15 March 2007

Subject: Former Arkema Portland Plant  
Responses to ODEQ/USEPA Comments on the Preliminary Draft Scoping  
Technical Memorandum  
Groundwater Source Control Interim Remedial Measures  
ECSI No. 398

Figure 4-2  
REVISED DRAFT SCHEDULE

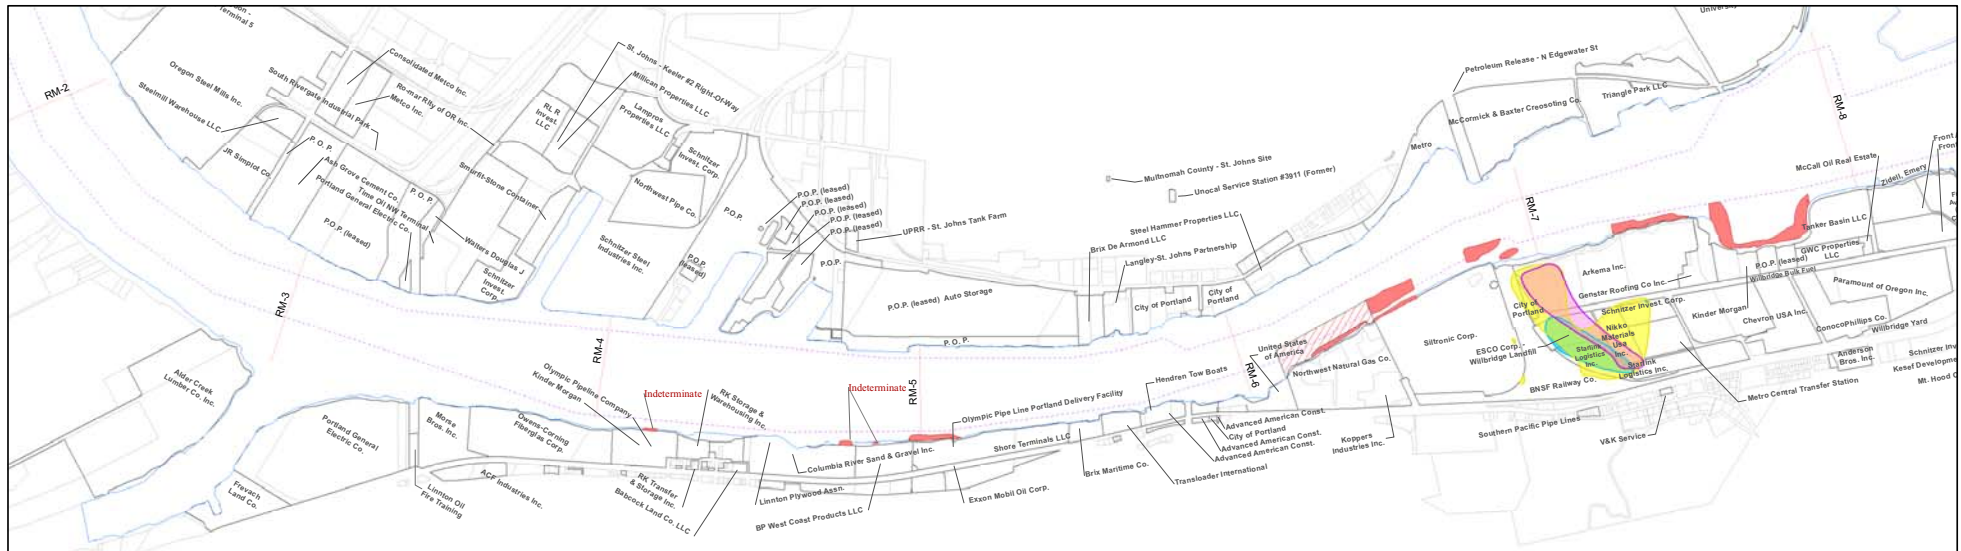
22. *Section 4.1.7 Installation, Startup, and Operation and Maintenance, Page 17 – This section references dry season construction. The construction schedule needs to accommodate the in-water removal action. This section should reference the in-water removal action and discuss how implementation will tie to the in-water work schedule.*

As shown on Figure 4-2, implementation of the groundwater IRM is planned for Summer 2009 and the EE/CA removal action is planned for Winter 2010. Therefore, it is not expected that implementation of these two actions will overlap. In the event that overlap is expected, LSS will notify the agencies of plans to synchronize the work.
